Department of Transportation
Region 1

Project Name: Canyons Far S

Review POC: Eyl, Aaron

2. Site development plan sheet 12

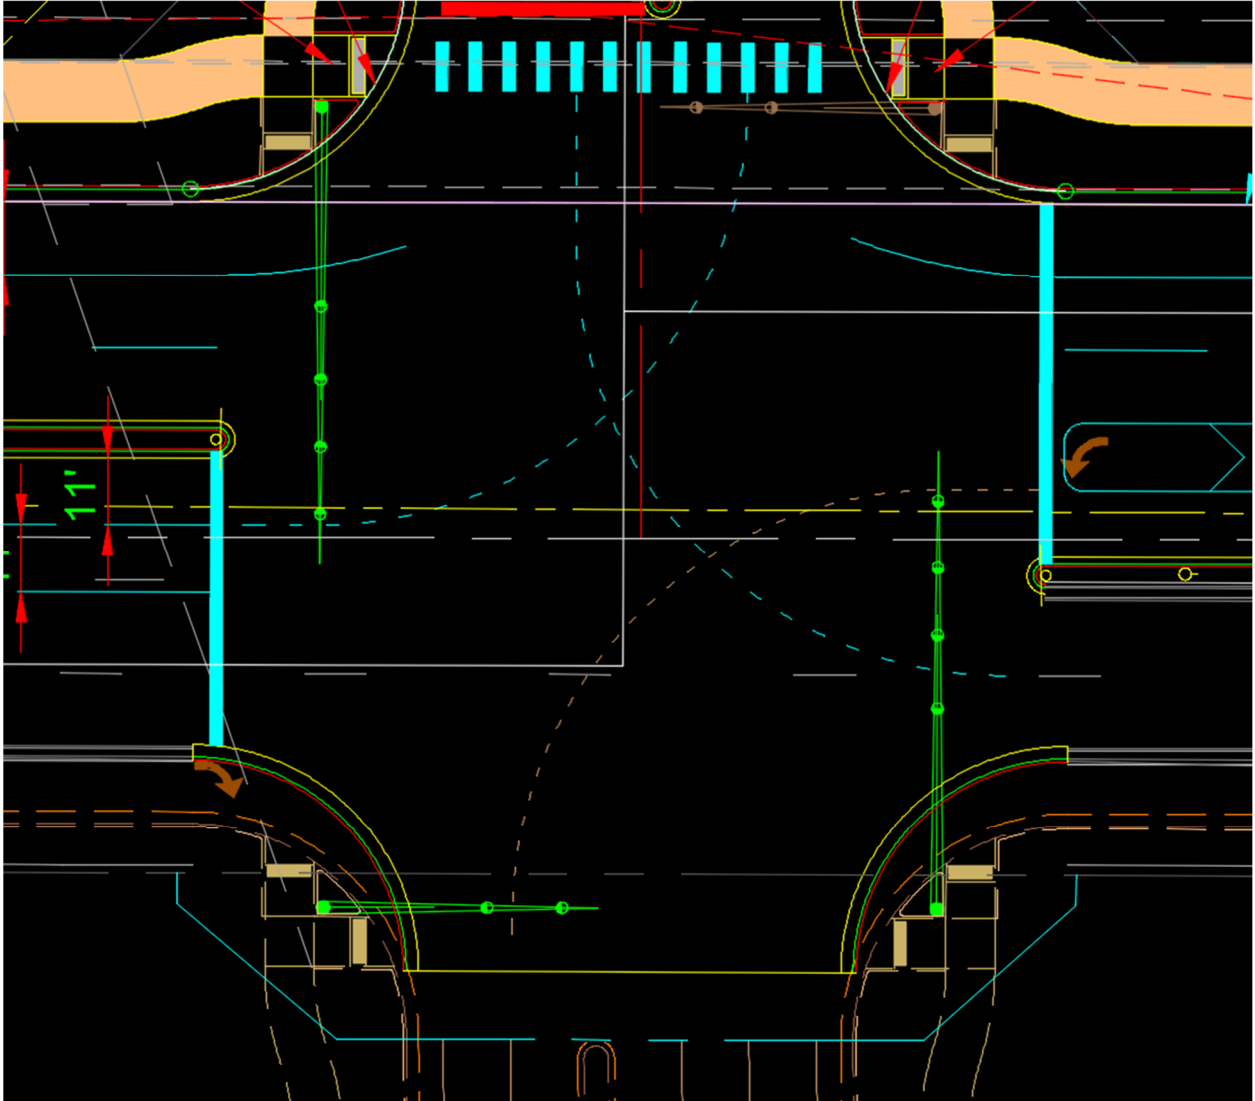
The WB to SB le turn lane is labelled as 11 wide, but that may include the theoretical 1 shoulder/gutter, making it a 10 lane. How far is traffic from the edge of any median posted signs?

Response: The widths provided are from stripe to edge of pavement. The turn lane has 11' of asphalt. The signs post will be 3.5-feet from the edge of pavement.
